Subject: Transmittal of Beazer's Comments on the GRU Team June 7, 2005 Report entitled "A Critique of the GeoTrans Flow and Transport Model, Koppers Inc. Site, Gainesville, Florida"

Attachment A:
Comments on GRU Team Report Entitled:
**“A Critique of the GeoTrans Flow and Transport Model, Koppers, Inc. Site,
Gainesville, Florida”**

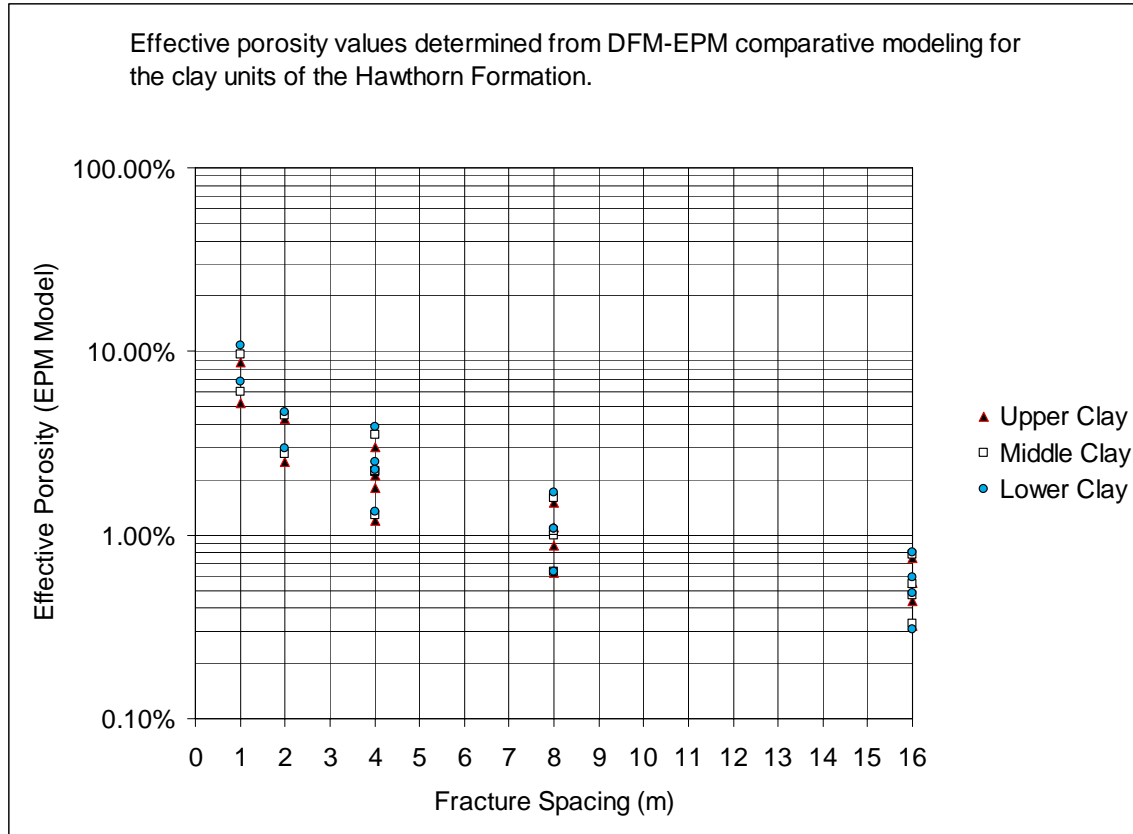
The GRU Team approach to estimating an effective-porosity value for modeling constituent transport at the Site is based on hydraulic calculations of fracture aperture using assumed values of fracture spacing, bulk hydraulic conductivity, and matrix hydraulic conductivity. In these calculations, the fracture spacing affects the fracture to matrix proportions; the smaller the fracture spacing, the smaller the fracture aperture. Because the one-dimensional transport solution used by the GRU Team for the fracture/matrix interactions assumes that the fracture blocks are infinite, the fracture spacing only affects the transport calculations through the effect on fracture aperture. The infinite matrix block assumption would tend to overestimate the retardation resulting from matrix diffusion over long timeframes. However, because the calculations are performed for a constituent that biodegrades, the distance over which the constituent diffuses into the matrix is limited to a few feet. Thus, the effect of the

infinite block assumption will be minor for the fracture spacings larger than a few feet. If sorption of the solute occurs in the matrix, the diffusion distance can be greatly reduced.

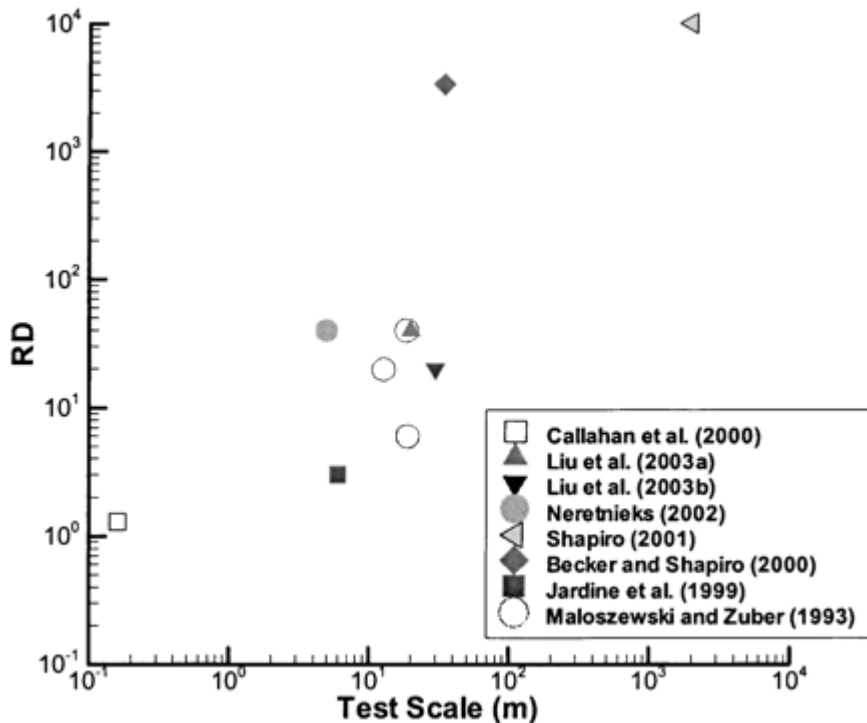
Just as the effective-porosity values reported for core samples are not representative of an aquifer REV, tracer tests on the scale of 100s of feet are also not representative of the aquifer REV. As demonstrated in the Robinson (1995) tracer test, a single, site-specific, secondary-dissolution feature dominated the tracer arrival time in the observation well; however, as the scale of the transport problem increases to that of the GeoTrans Model, the combined effect of numerous, individual site-specific features likely behave as an equivalent porous media. This observation was also demonstrated in the Renken et al., (2005) tracer tests conducted in the

Biscayne aquifer in southeast Florida. Vuggy, stratified flow zones dominate the tracer arrival time in the observation well 328 ft away. The authors reference multiple groundwater flow models of the Biscayne aquifer where an effective-porosity value of 20 percent was used for regional scale applications (Renken, R. A. et al., 2005, p. 326). Hence, small-scale measurements of effective-porosity values on cores and in-situ tracer tests in dual-porosity carbonate aquifers are not representative or appropriate for most model applications.

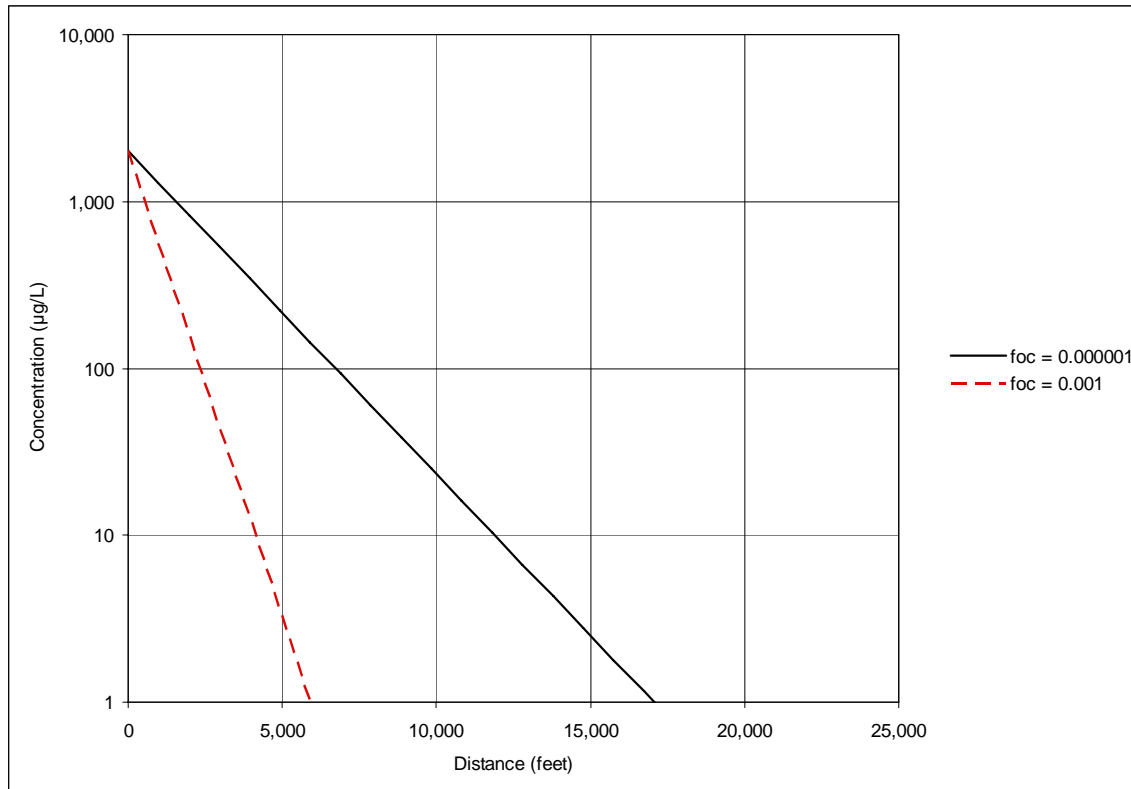
There has been relatively little research on sorption processes within limestones. A study by Witthuser et al. (2003) evaluated naphthalene sorption onto two chalks from Israel. These samples varied in their f_{oc} values. Batch sorption experiments [K_d values of 1.18 ($f_{oc} = 0.00047$) and 31.4 L/kg ($f_{oc} = 0.00642$)] indicate that some sorption occurs even at low f_{oc} values. To illustrate the impact of even minor sorption (see figure below), the value of f_{oc} was

set to 0.001, yielding a K_d of 1.19 ml/g, in the GRU Team dual-porosity model which used a half life of 3 years, bulk hydraulic-conductivity value of 23 ft/d and fracture spacing of 4 m. Results indicate a reduction in transport of naphthalene by a factor of approximately 1/3.
